Product/Process Change Notice (PCN)

<p>PCN Number: PCN_AsSPAIE_20241120</p> <p>Affected Series: WA-SPAIE</p> <p>Affected Order Codes: see table below</p> <p>PCN Date: 2024-08-20 (YYYY-MM-DD)</p> <p>Effective Date: 2024-11-20 (YYYY-MM-DD)</p>	<p>Change Category:</p> <p><input type="checkbox"/> Equipment/Location</p> <p><input checked="" type="checkbox"/> General Data</p> <p><input type="checkbox"/> Material</p> <p><input type="checkbox"/> Process</p> <p><input type="checkbox"/> Product Design</p> <p><input type="checkbox"/> Shipping/Packaging</p> <p><input type="checkbox"/> Supplier</p> <p><input type="checkbox"/> Software</p>																																													
<p>Contact: Product Management</p> <p>Phone: +49 (0) 7942 - 945 5001</p> <p>Fax: +49 (0) 7942 - 945 5179</p> <p>E-Mail: pcn.eican@we-online.com</p>	<p>Datasheet Change:</p> <p><input checked="" type="checkbox"/> Yes <input type="checkbox"/> No</p> <p>Attachment:</p> <p><input type="checkbox"/> Yes <input checked="" type="checkbox"/> No</p>																																													
<p>Description of Change:</p> <p>Because of a database mismatch, Würth Elektronik eiSos update 3D models & datasheets. All products/L

Before change	After change

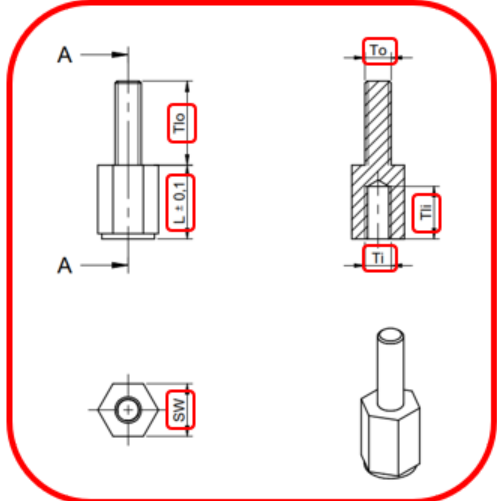
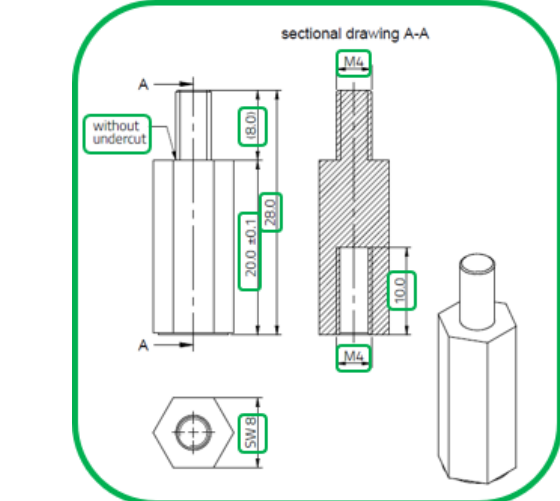
Updated dimensions and 3D models e.g. drawing section below
